Subject: Request for Continued Use of DOT Specification 20WC-5/2R after October 1, 2008

**Subject: Request for Special Permit**

Subject: Special Permit Application, Docket Number 14728-N, Response to Comments

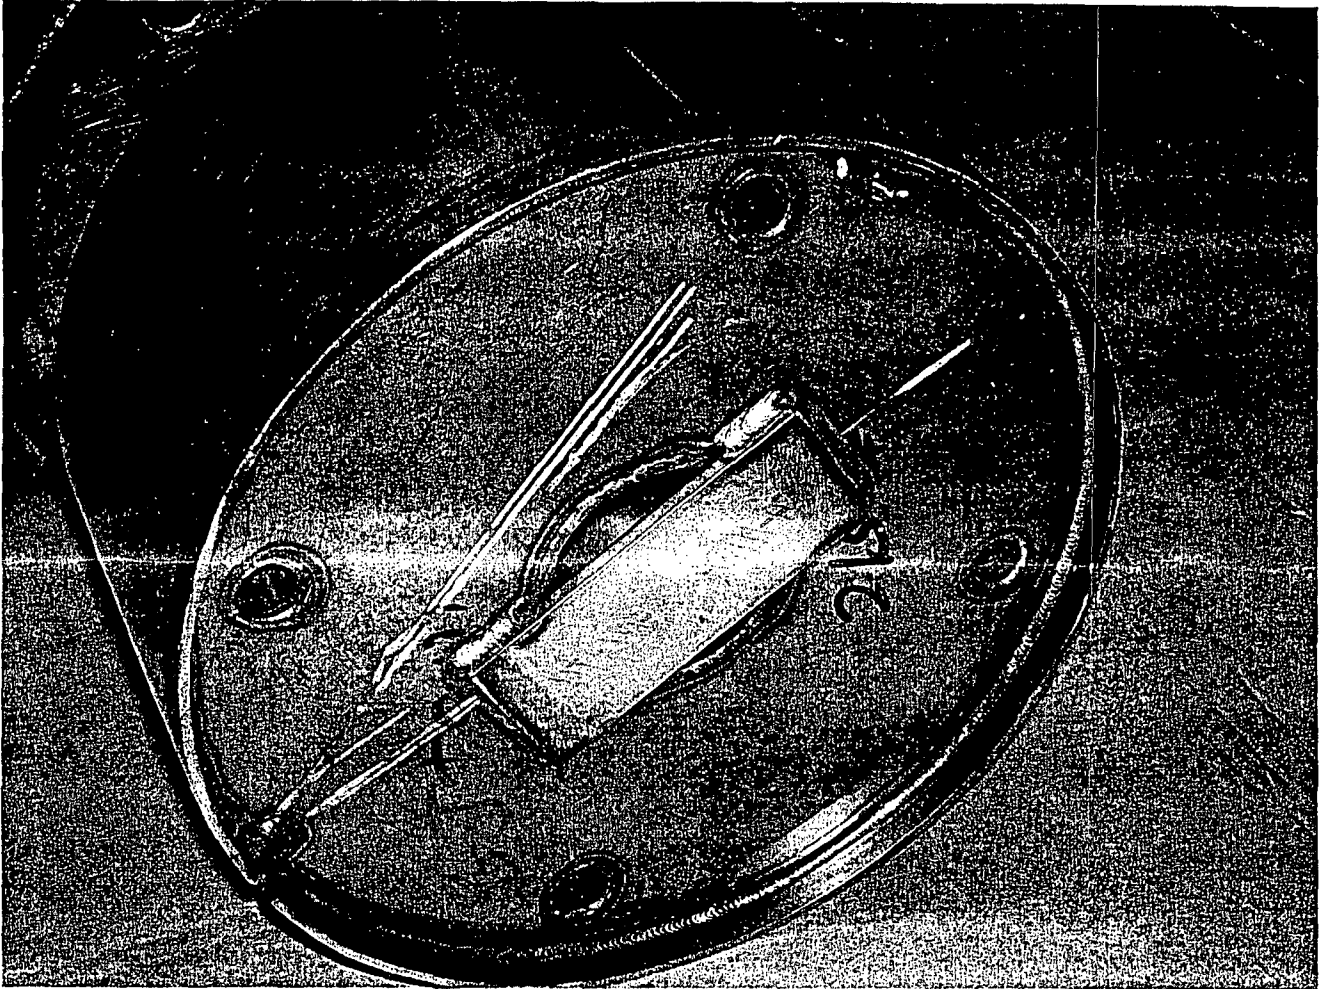
DOT Comment 3: Provide a detailed explanation as to what prevents the tungsten bottom plug from falling out of tungsten shield.

INIS Response to Comment 3: A stainless steel bar is welded across the bottom opening of the shield to hold the tungsten bottom plug in place. A photograph of bottom of the tungsten shield is provided on the following page.
